REPORT TO THE SUBDIVISION AND DEVELOPMENT APPEAL BOARD

DATE: September 29, 2026	**APPEAL NO.: SDAB2026-0164** **FILE NO.: DP2025-04672**
APPEAL BY: Rafih Bari	
FROM A DECISION OF THE DEVELOPMENT AUTHORITY where a **New: Rowhouse Building (1 building)** **was refused at 286 Covepark Way NE.**	**LAND USE DESIGNATION: R-G** **Permitted with a Relaxation**
COMMUNITY OF: Coventry Hills	**DATE OF DECISION: August 20, 2026**
APPLICANT: Rafih Bari	**OWNERS: Chowdhury Fazle Bari & Midori Taguchi**

Application Number:	**DP2025-04672**
Application Description:	New: Rowhouse Building (1 building)
Land Use District:	Residential - Low Density Mixed Housing
Use Type:	Permitted with a Relaxation
Site Address:	286 COVEPARK WY NE
Community:	COVENTRY HILLS
Applicant:	Bari, Rafih - CIRNO DESIGN
Date DR Sent:	February 19, 2026
Response Due Date:	April 20, 2026
Development Applications Review Team	
Planning:	STEPHANIE CANTLAY (587) 892-0311 Stephanie.Cantlay@calgary.ca
Utility Engineering:	DINO DI TOSTO 403-268-2131 Dino.diTosto@calgary.ca
Mobility Engineering:	AADIL AMJAD Aadil.Amjad@calgary.ca

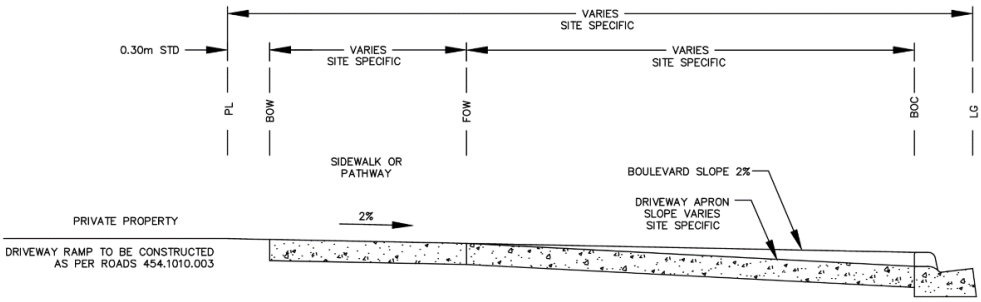
Utility Engineering - Water Servicing
a) Indicate an adequate water meter area where the services (50mm and smaller) enter the building.

Water meter location must be shown on the Development Permit plans and match the DSSP. The water meter area must have all meters in the same place and not under stairwells as there needs to be a minimum height clearance of 2m. The DSSP application will be rejected if the Development Permit plans are not updated with the water meter room/location.

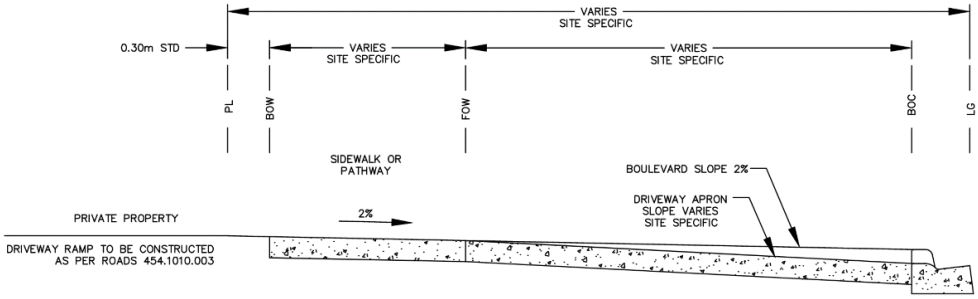
Utility Engineering - Water Servicing
a) Indicate an adequate water meter area where the services (50mm and smaller) enter the building.

Water meter location must be shown on the Development Permit plans and match the DSSP. The water meter area must have all meters in the same place and not under stairwells as there needs to be a minimum height clearance of 2m. The DSSP application will be rejected if the Development Permit plans are not updated with the water meter room/location.

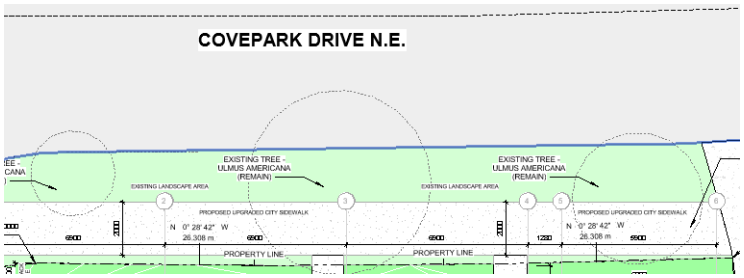
2. Amend plans to address the bylaw discrepancies noted in the Bylaw Discrepancies Table of this document. Alternatively, provide planning rationale in a written submission supporting any proposed relaxations to address the bylaw discrepancies noted in Bylaw Discrepancies Table of this document.

Suteki: The discrepancies have been addressed on this response.

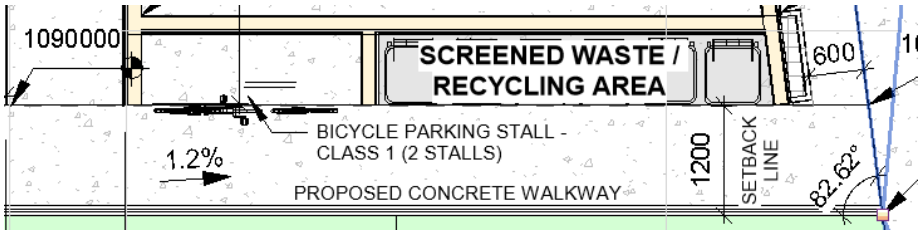
5. Revise the labelling for the bicycle stalls. Class 1 bike stalls are considered within a secure location. The stalls on the on exterior of garage are considered class 2, not class 1. See Mobility comments for further information on appropriate specifications.

Suteki: The label for the bicycle stall outside of the garage has been updated from class 1 to class 2. See A201.

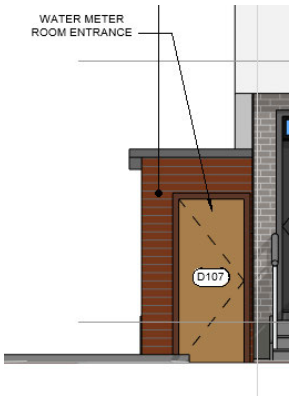
6. Please label what this portion of the building connected to Unit 1 is. Clarify if it is an entrance, shed, or something else. Amend the plans to be consistent in size and shape on all plans.

Suteki: The shed connected to unit 1 is an external water meter room. The door and the purpose of the shed have been labeled. See A201 and A301.

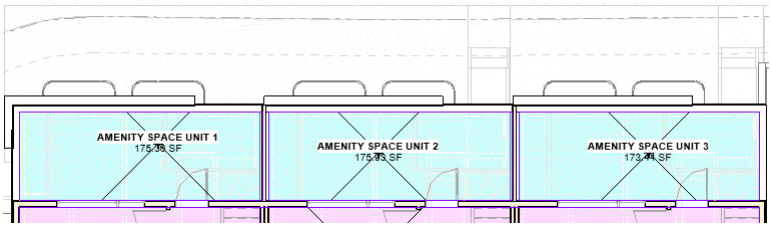
7. Amend the plans to allow the secondary suite floor more access to light. The windows for the suites are all below grade and do not provide much access to natural light.

Suteki: the secondary suite has been removed. Now the basement has become part of the main dwelling unit.

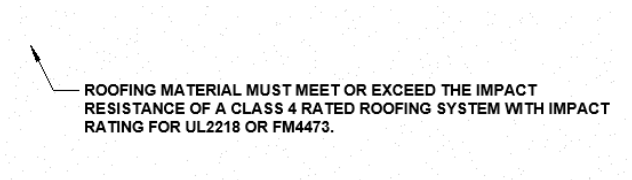
Potential options for solar PV ready details may include, at least 2.5 cm (1") nominal diameter constructed of rigid or flexible metal conduit, electrical metallic tubing, or cables with a metal armour or metal sheath.

Alternately, a 2" vacuum tube with twine pulled through and a card on each end, to accommodate future installation, will meet the intent of the condition.

Suteki: A socket panel has been added to the roof for future solar panel installation. See A204.

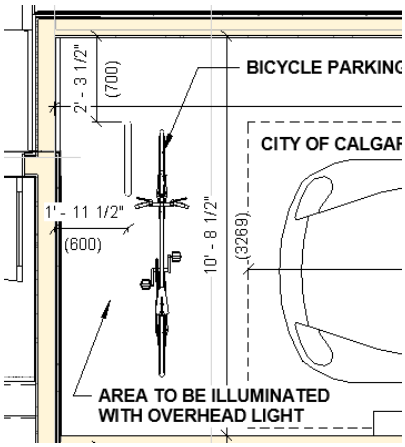
Amend plans to include a detailed layout of Class 1 bicycle stalls that meets the minimum standards outlined in the Land Use Bylaw and the City's Bicycle Parking Handbook. Specifically:

• Indicate door location and full door swing direction, ensuring a minimum 2.0m clearance from any barriers. No secured doors are depicted on the plan.

• Ensure stalls are in a secured, weather-protected structure (e.g., lockers or controlled-access rooms). Stalls seem to be in the open on the plan.

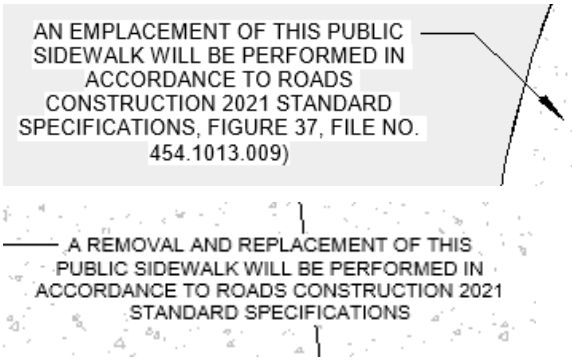
28. Public Sidewalk Upgrade
The existing sidewalks adjacent to the development parcel do not meet the City of Calgary standard sidewalk width.

Amend plans to show and clearly label the removal and replacement of sidewalks along Covepark WY NE and Covepark DR NE, classified as Residential and Collector, in accordance with the City¿s Design Guidelines for Subdivision Servicing and Road Construction Standards. Specifically:

• For Residential streets, provide and label 1.5m monolithic sidewalk with standard curb (actual width is 1.61m); dimension the back of walk accordingly (Refer to Roads Construction 2021 Standard Specifications, Figure 37, File No. 454.1013.009)

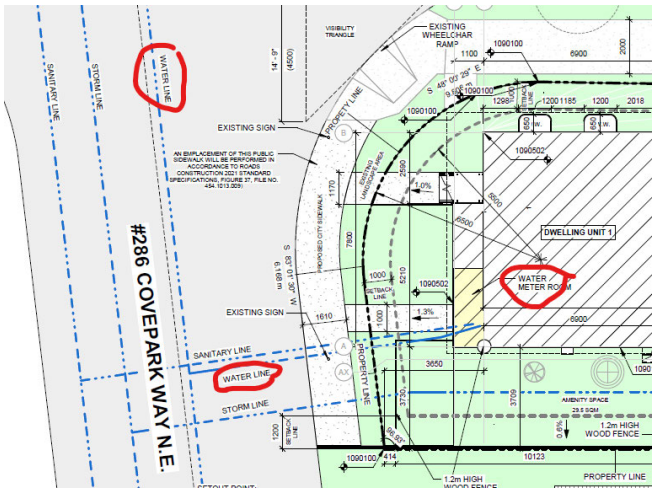
DR2 Update: Additional bicycle stalls are not required as secondary suites have been removed. The class 2 located at the side setback can be removed.

Suteki: The additional bicycle stall has been removed. See A100.
